RENESAS TECHNICAL UPDATE

Product Category	MPU/MCU		Document No.	TN-SH7-A859A/E	Rev.	1.00
Title	Errata to User's Manual Regarding CAN Module		Information Category	Technical Notification		
Applicable Product	SH7450 Group, SH7451 Group SH7455 Group, SH7456 Group	Lot No.	Reference Document	SH7450 Group, SH7451 Group User's Manual: Hardware REV.1.10		
				SH7455 Group, SH7456 Group User's Manual: Hardware REV.1.10

This document describes corrections to the chapter "CAN module" in the User's Manuals: Hardware of the above groups.

Figure 26.9 Transition between CAN Operating Modes (i = 0 to 4)

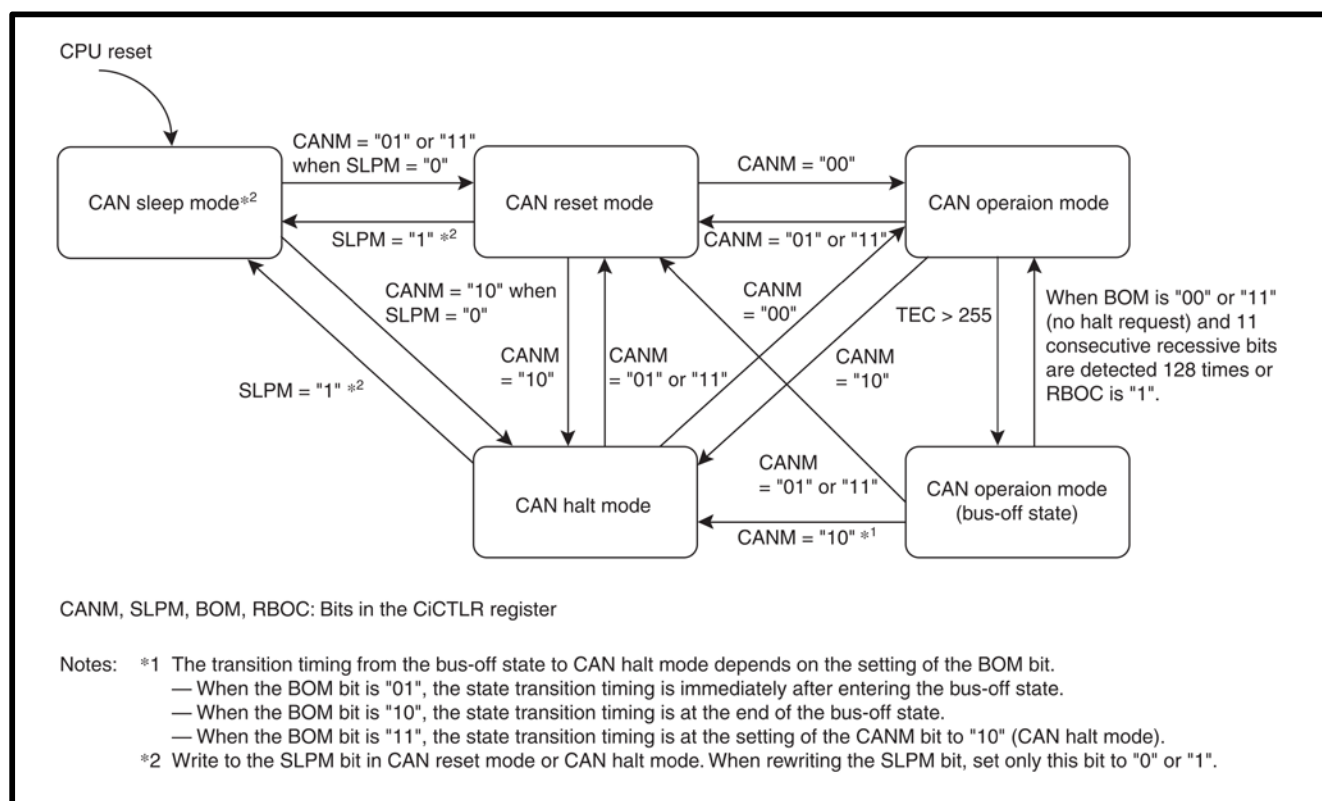
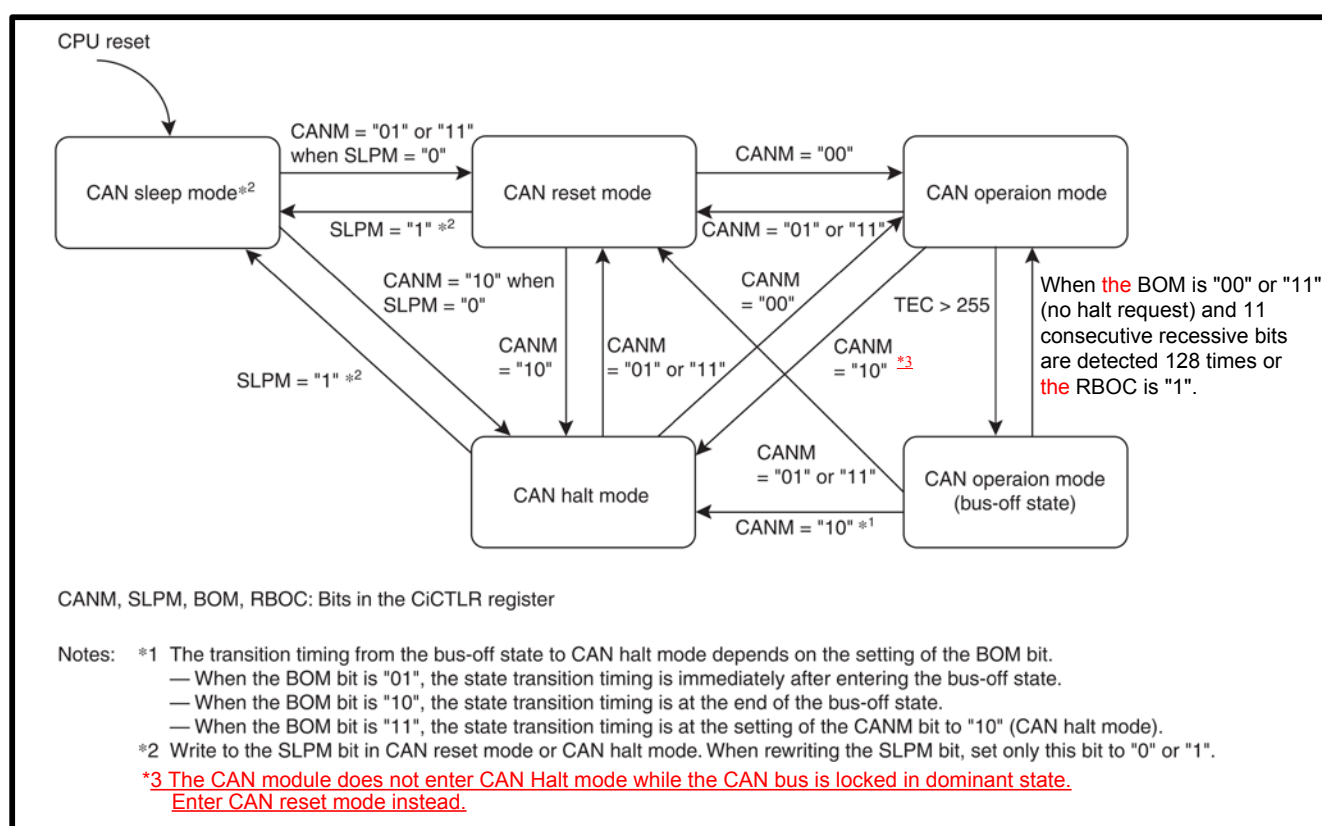
• Page 26-72

The description in Figure 26.9 Transition between CAN Operating Modes is corrected as follows:
